# University of Kentucky<sup>®</sup>

CCK-2564.0-9-24

Construct Health Education Building

ADDENDUM #3

**S-006**  
 COPYRIGHT 2024 - JRA, INC.

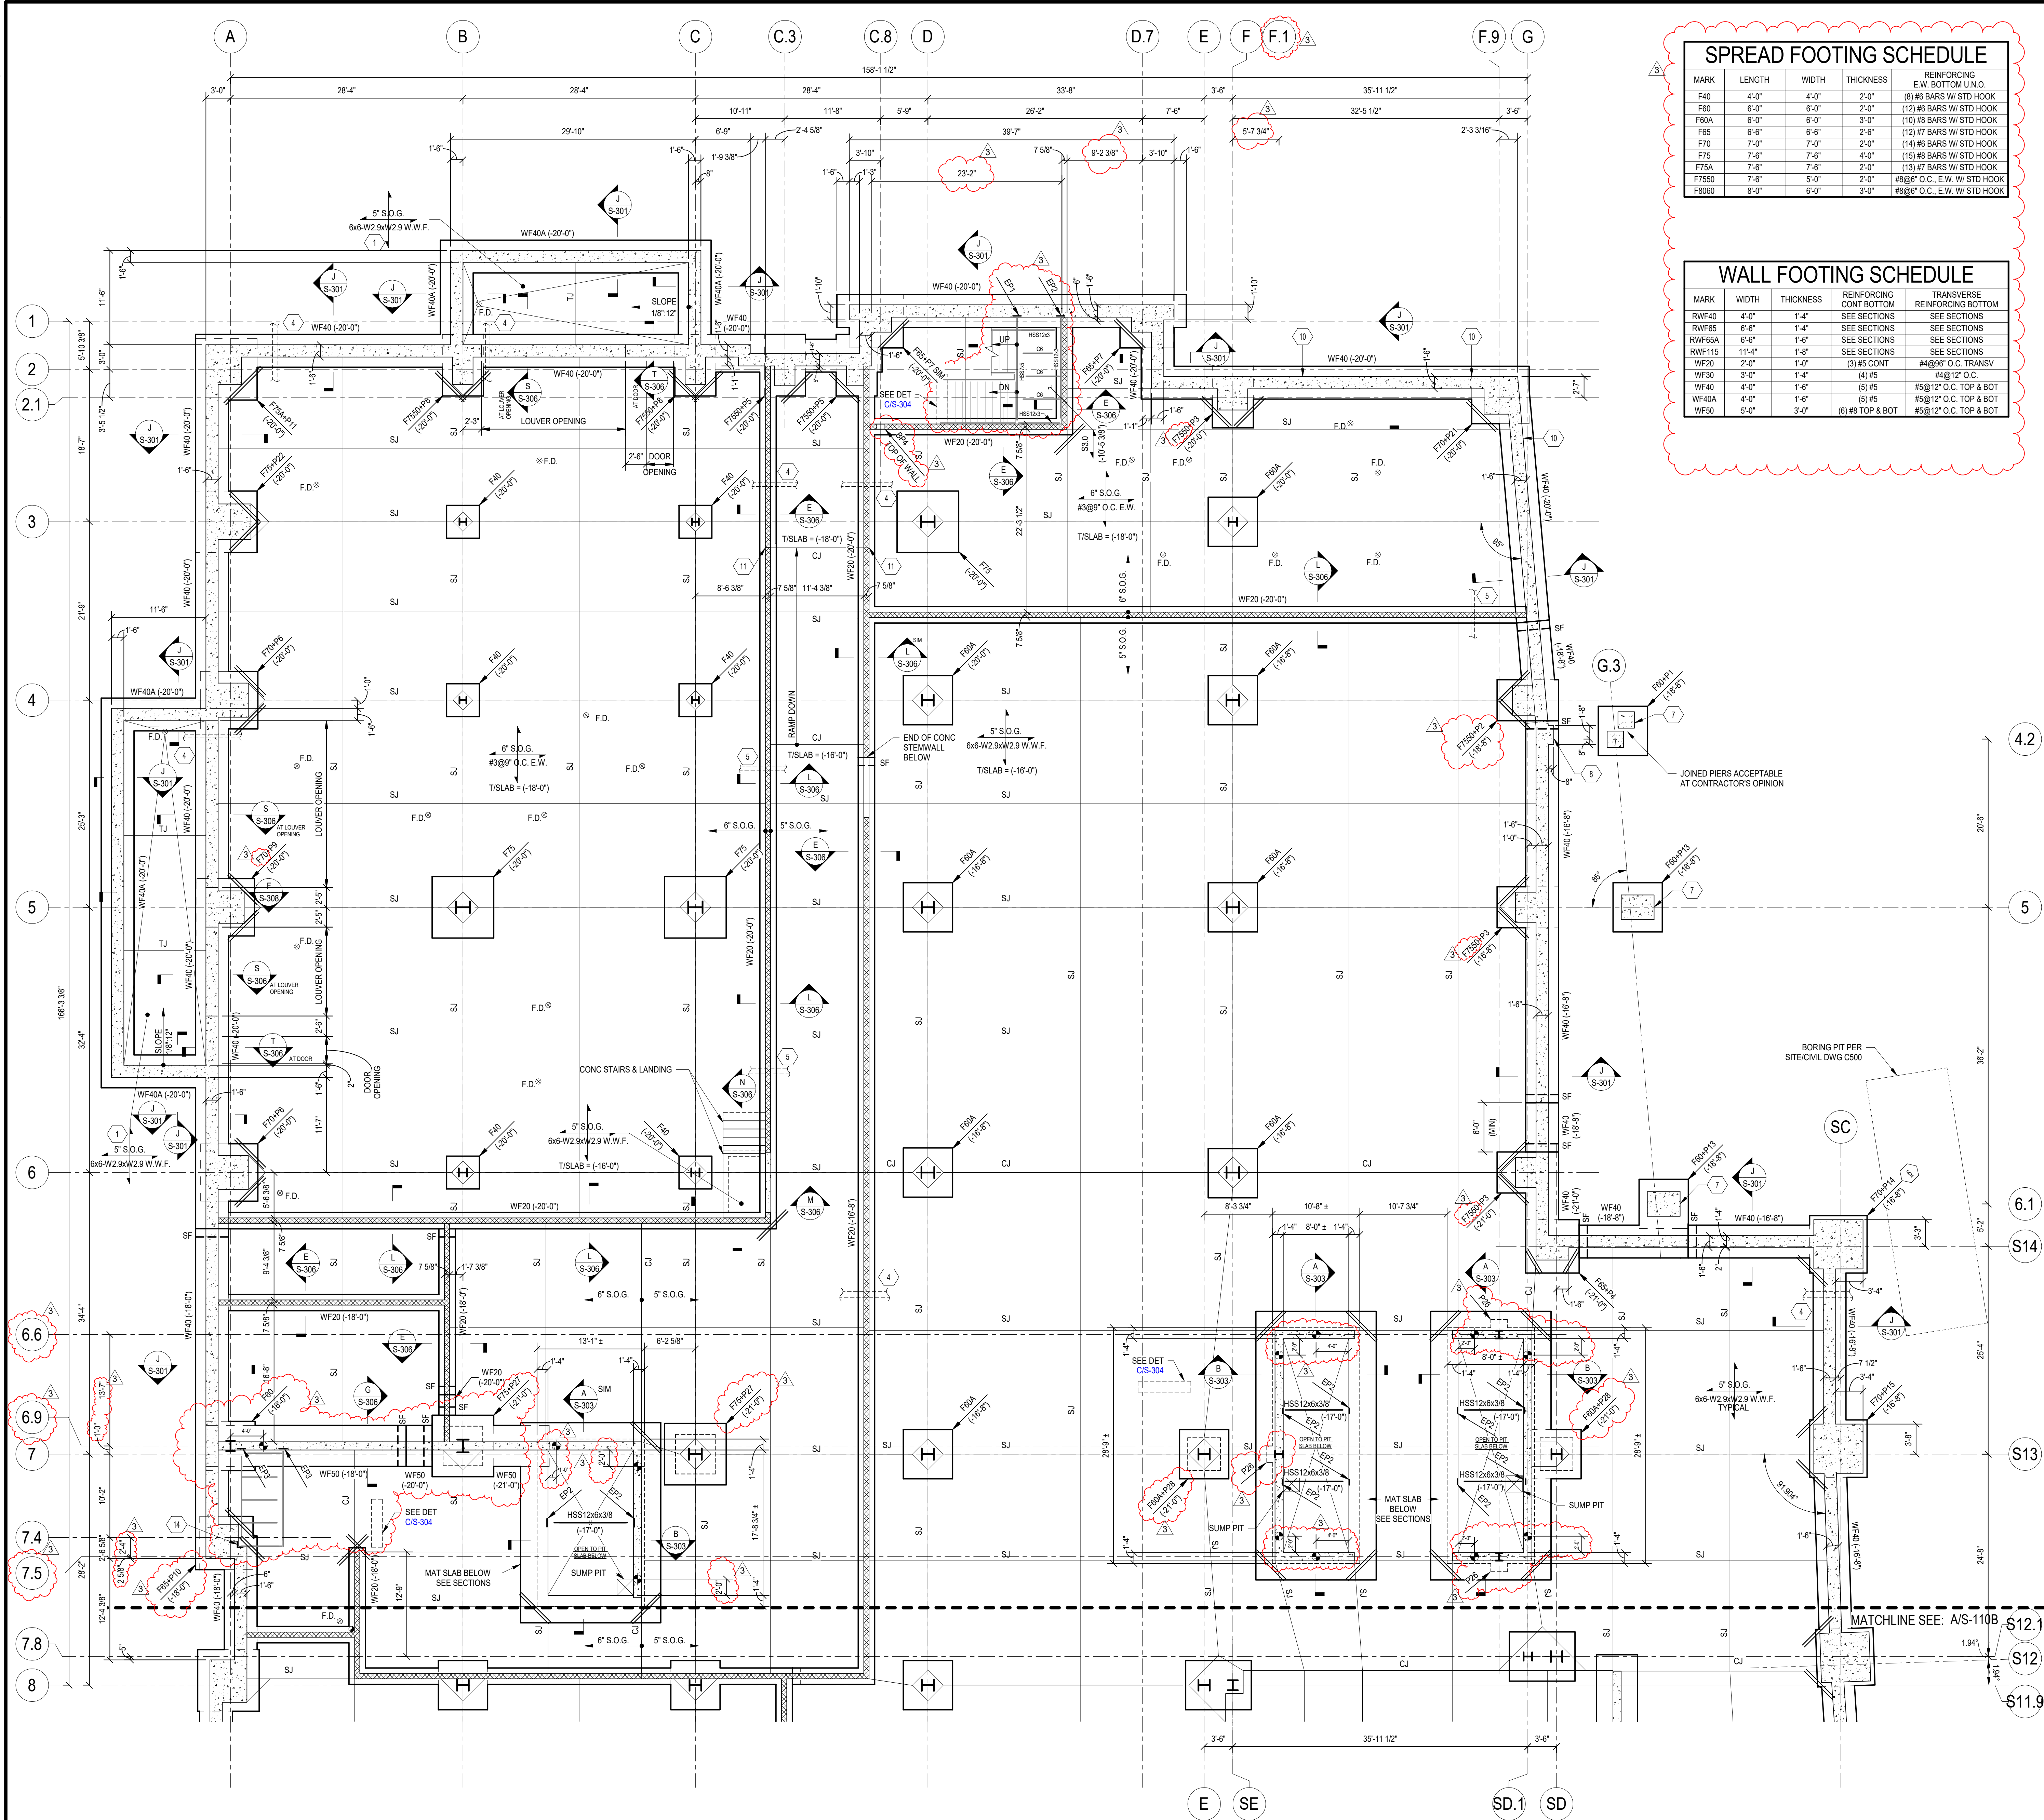
Refer to attached sheet S-006. Added/modified gridlines and layout as design development progressed.

**FOUNDATION PLAN - BASEMENT LEVEL - AREA A**  
**S-110A**  
COPYRIGHT 2024 - JRA, INC.

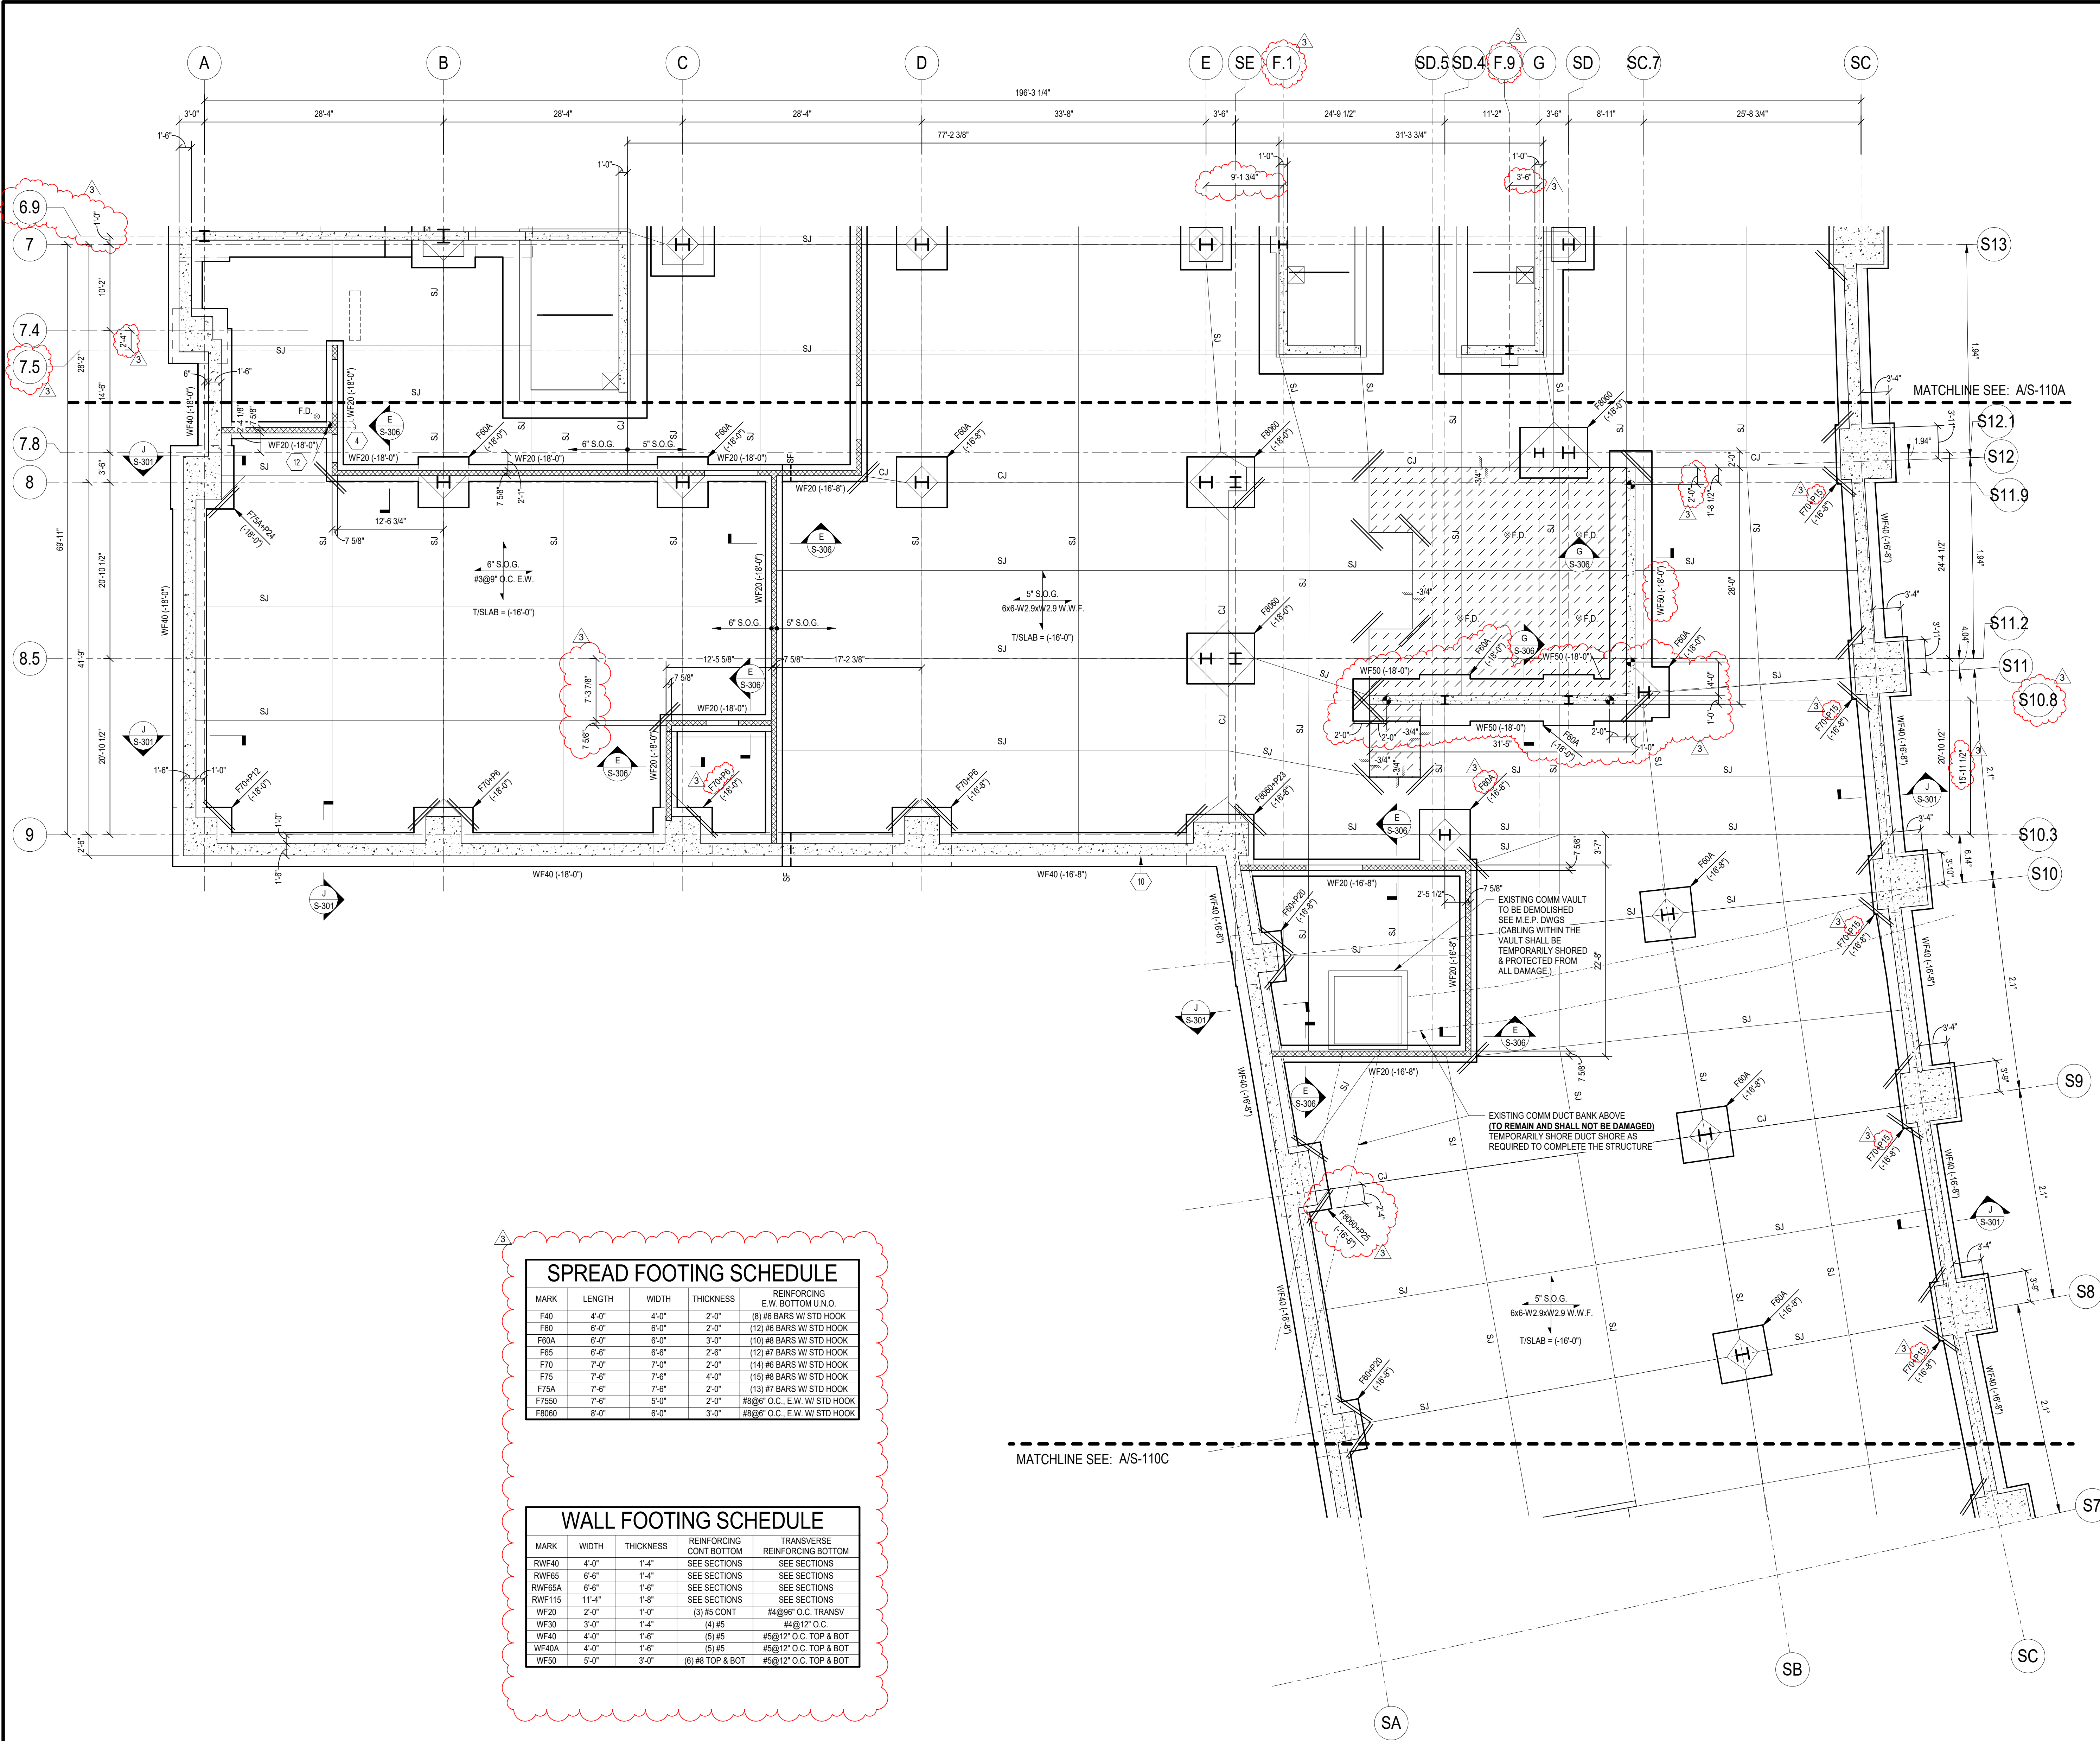
Refer to attached sheet S-110A. Foundation Tag Notes moved to sheet S-002. Updated Foundation Plan Notes. Spread Footing Schedule changes to footing sizes and reinforcement. Updated embed and bearing plates, gridlines and dimensions, rock anchor locations, pier sizes/locations, and footing sizes/locations, additional piers and footings for added columns. Added concrete beam for lateral wall support at west areaway.

**FOUNDATION PLAN - BASEMENT LEVEL - AREA B**  
**S-110B**  
COPYRIGHT 2024 - JRA, INC.

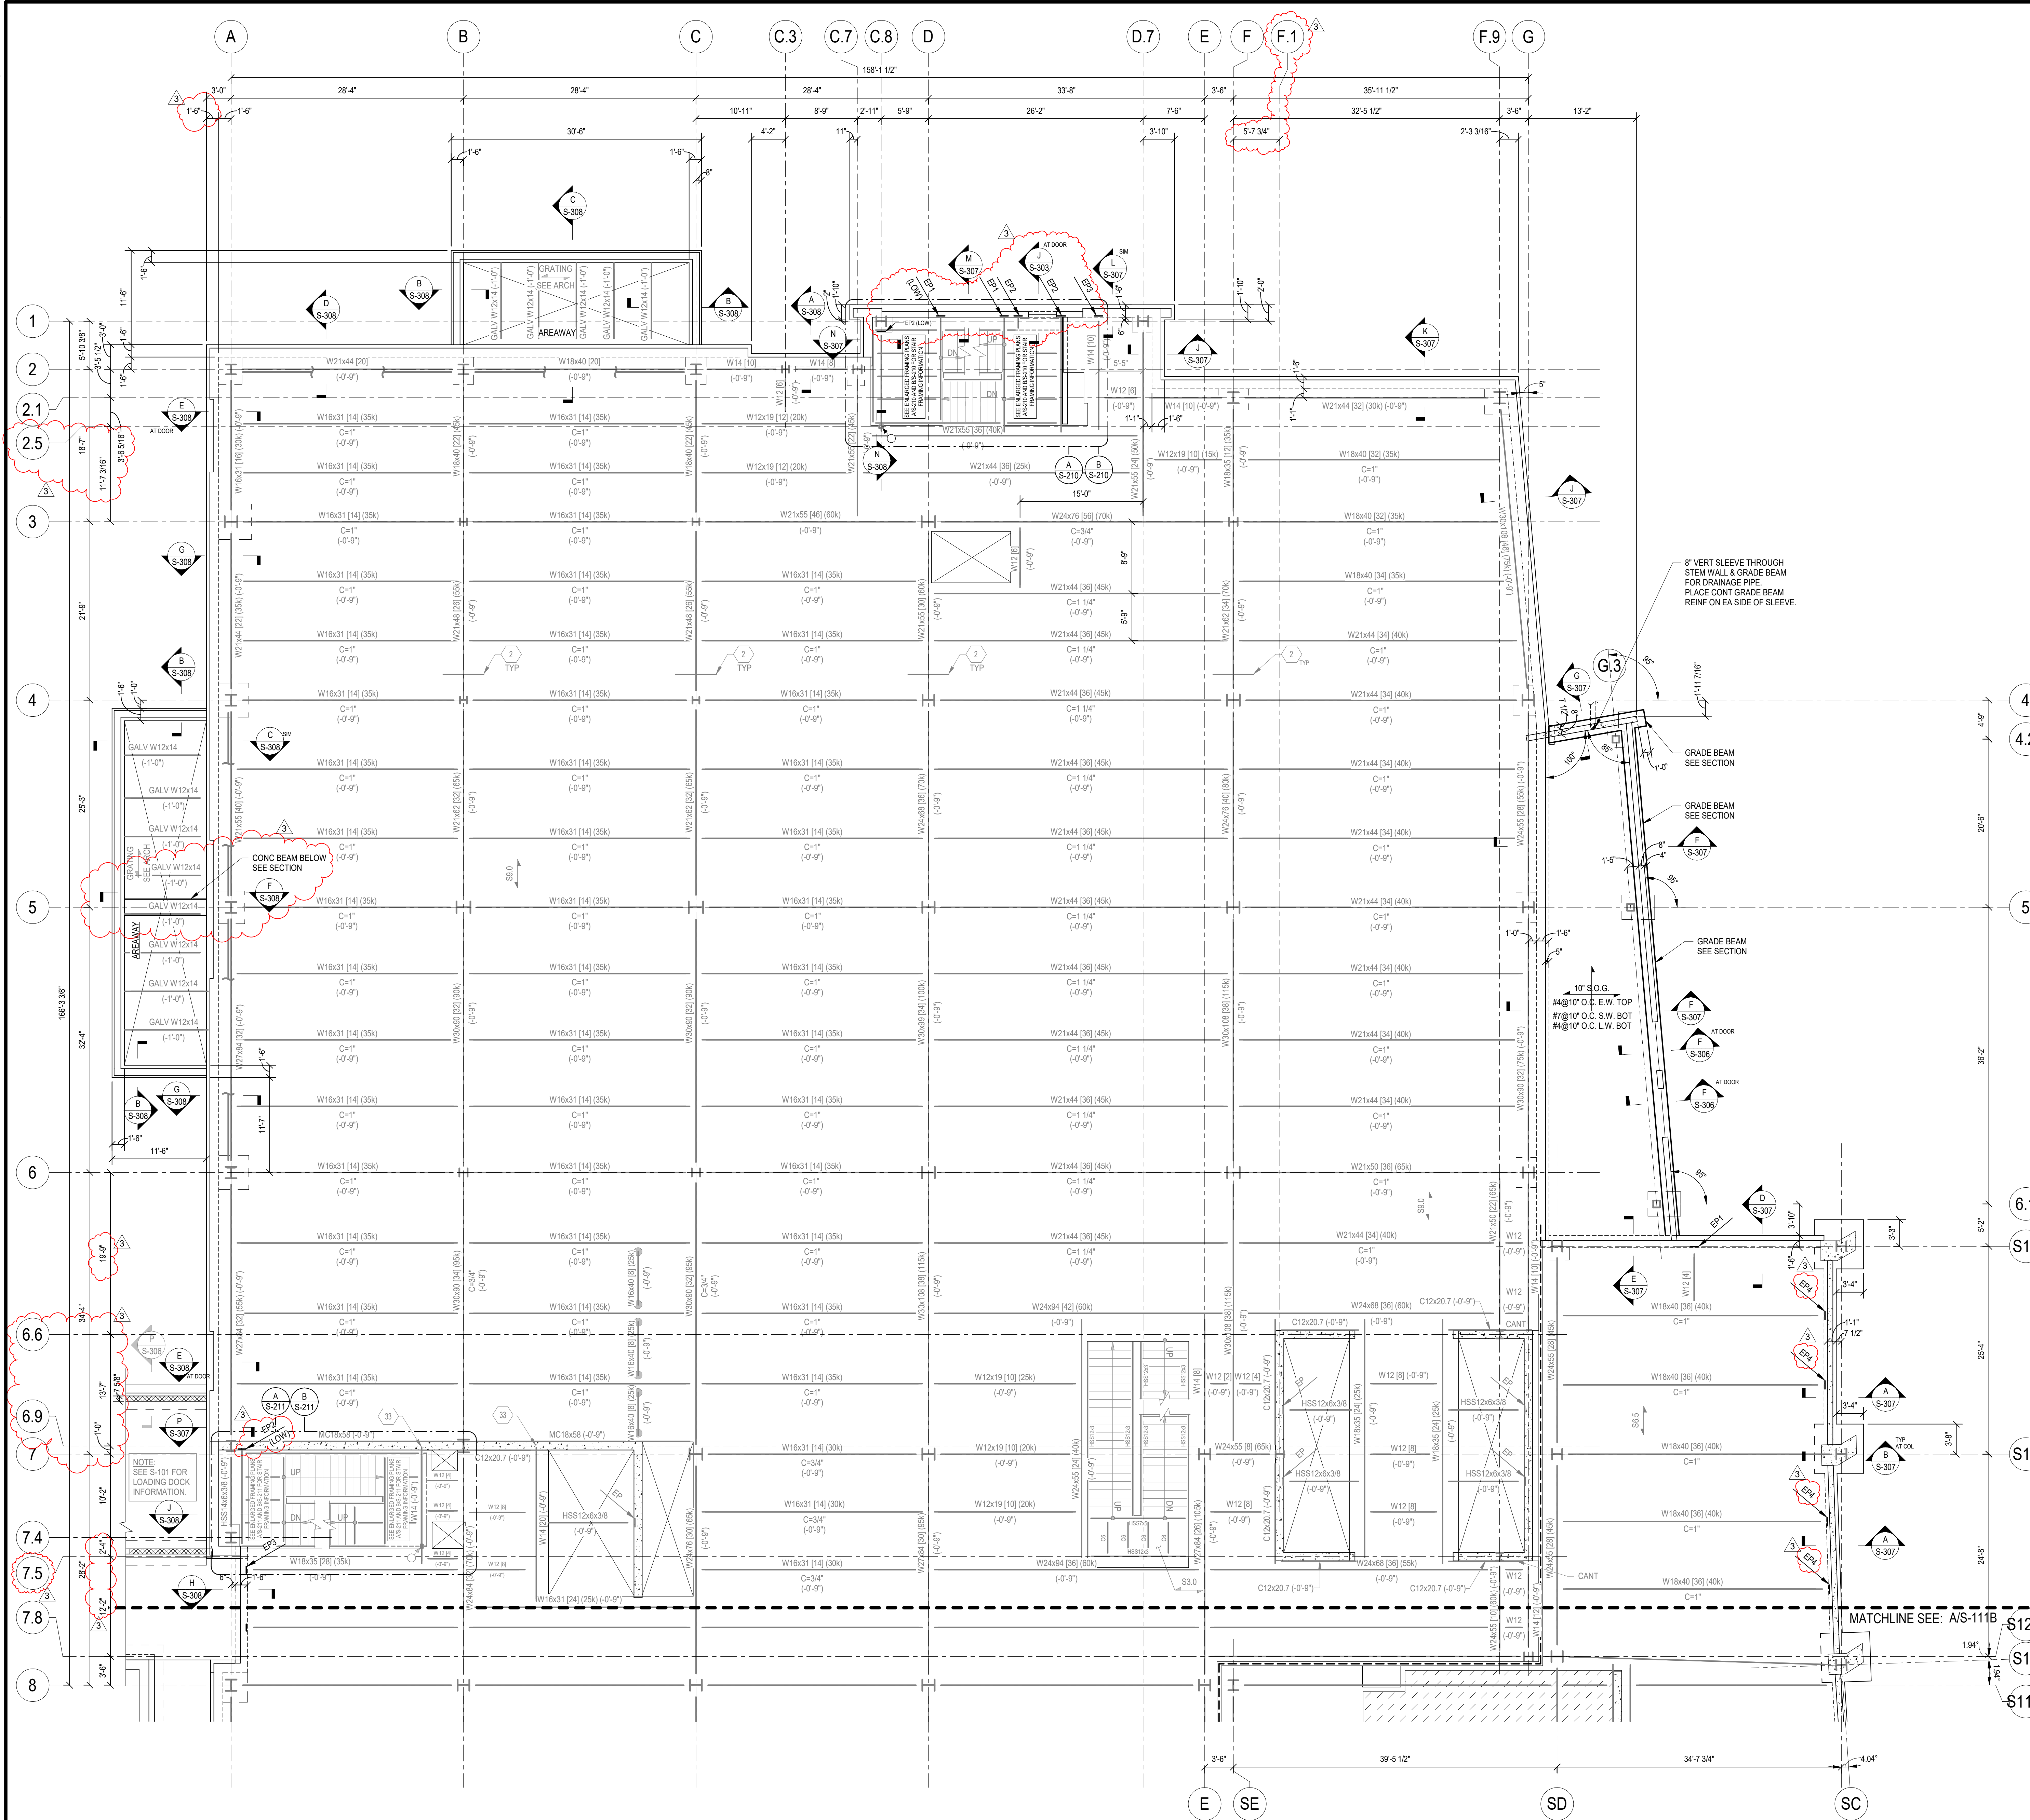
Refer to attached sheet S-110B. Foundation Tag Notes moved to sheet S-002. Updated Foundation Plan Notes. Spread Footing Schedule changes to footing sizes and reinforcement. Updated gridlines and
